AMENDMENT NO. 3 JULY 1980
TO
IS : 2750-1964 SPECIFICATION FOR
STEEL SCAFFOLDINGS

FIG. 9 TEST FOR DISTORTION OF SWIVEL COUPLERS

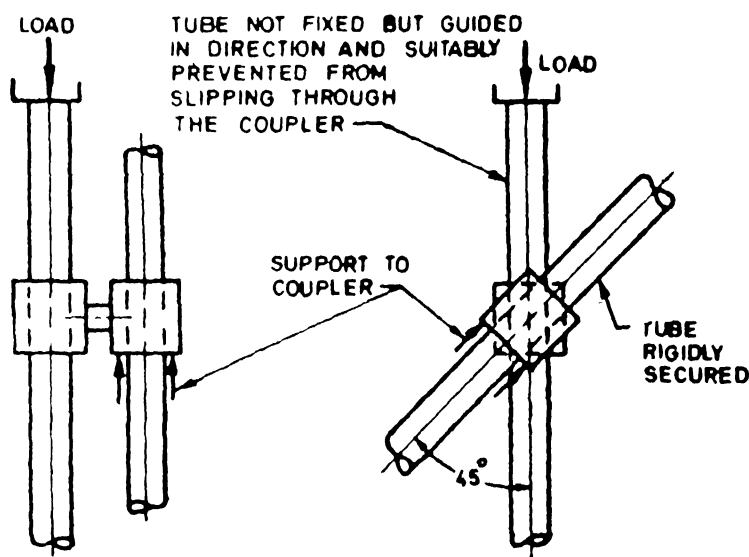
[Page 18, clause 7.3.5.1(a) and (b)] — Substitute the following for the existing matter:

- a) *Test for distortion* — The coupler, connecting two tubes at a 45° angle and suitably prevented from slipping on both tubes as shown in Fig. 9 shall be capable of supporting without distortion a load of 1.5 tonnes.
- b) *Test for slip* — The coupler, connecting two tubes at a 45° angle as shown in Fig. 10 shall be capable of sustaining a load of 1.25 tonnes applied to the vertical tube. During this test the coupler shall not rotate through an angle greater than 10° from the horizontal.

FIG. 11 RIG FOR SLIP TESTS ON PUTLOG COUPLERS

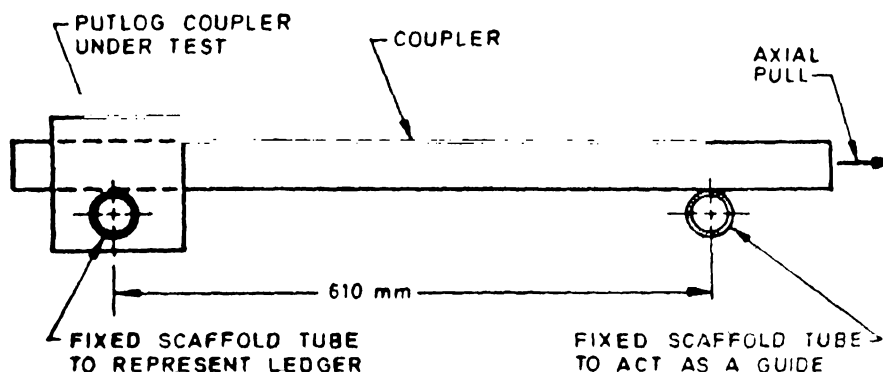
(Page 18, clause 7.3.6) — Substitute the following for the existing clause:

7.3.6 Putlog Couplers — The grip afforded by a putlog coupler shall offer adequate resistance to horizontal or axial rotation, slip or accidental displacement of a putlog. A putlog coupler shall be capable of passing the following test:

Test for Slip — The coupler connecting two tubes at right angles, as shown in Fig. 11 and assembled as recommended by the manufacturer, shall be capable of sustaining load of 130 kg applied to the horizontal putlog or transom.

NOTE — A putlog coupler shall be capable of satisfying the test for slip and shall be of such a shape as to be readily distinguishable from a right angle coupler.
